REVISED RESPONSE TO REQUEST FOR ADDITIONAL INFORMATION**APR1400 Design Certification****Korea Electric Power Corporation / Korea Hydro & Nuclear Power Co., LTD****Docket No. 52-046**

RAI No.: 347-8435

SRP Section: 15.04.03 – Control Rod Misoperation (System Malfunction or Operator Error)

Question No. 15.04.03-1**REQUIREMENTS AND GUIDANCE**

Figure 1. Time vs. Core Average Heat Flux (12-Finger CEA Drop)

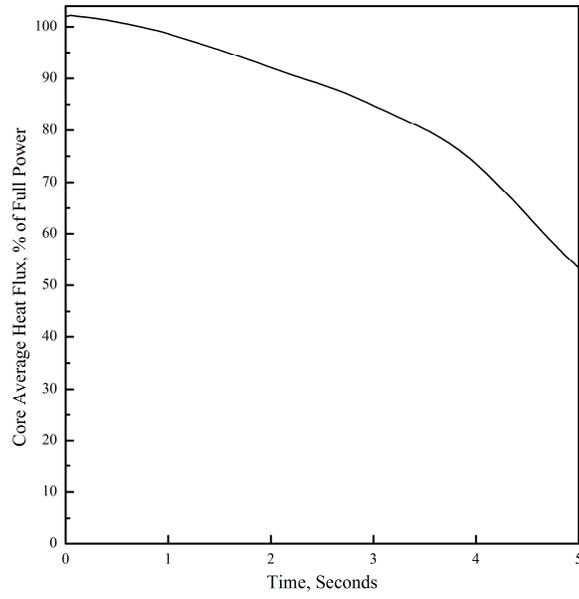
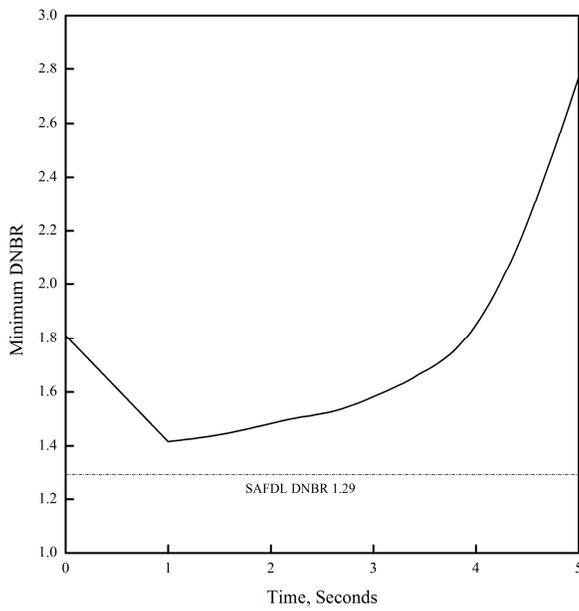
In addition, the audited calculation note indicates that, as of August 2012, the 12-finger CEA drop had not been evaluated but will be in future analyses for the core operating limiting supervisory system (COLSS) and the core protection calculator system (CPCS). The calculation note also states that, if a 12-finger CEA drops, the CPCS will appropriately generate a trip if it is necessary because the CPCS conservatively calculates DNBR every 0.05 seconds. The applicant has nevertheless provided no information on its analyses for 12-finger CEA drop events. Absent such information, the staff can neither assess the applicant's analyses for a range of 12-finger CEA drop events nor verify their implications, if any, for determining the limiting CEA drop event.

Please provide justification that the four-finger single CEA drop is the limiting event for DCD Section 15.4.3. A summary of analysis results using different rodged core configurations, dropped rod types and locations, and different cycle conditions would assist the reviewer in confirming that the event analyzed is the limiting event. Supporting information should include the basis for the maximum radial peak distortion factor of 1.205 as well as a summary of analyses performed for 12-finger CEA drop events.

In case of 12-finger CEA drop, the thermal margin reduction caused by Fr distortion with xenon redistribution effect is significant. If the thermal margin reduction by 12-finger CEA drop is covered by preserved thermal margin, the LCOs have to be excessively limited. Therefore, in case of 12-finger CEA drop, CPCS functionalized to protect the reactor from DNBR or LPD limit violation by applying a predetermined penalty factor to DNBR and LPD calculation in CPC.

Figure 1 and Figure 2 show the typical heat flux and DNBR behavior during the 12-finger CEA drop event. In this analysis, the 12-finger CEA drop occurs at 0 seconds and CPC generate reactor trip signal at 0.85 seconds including the processing delay time and reactor trip breaker opening time. And considering the holding coil decay time (0.5 seconds), scram rods begin to drop into the core at 1.35 seconds. Although the DNBR is decreased due to the static Fr distortion within 1 second, the DNBR begins to increase in combination with heat flux decrease by 12-finger CEA drop. After that, the minimum DNBR is maintained above the DNB SAFDL by CPC trip.
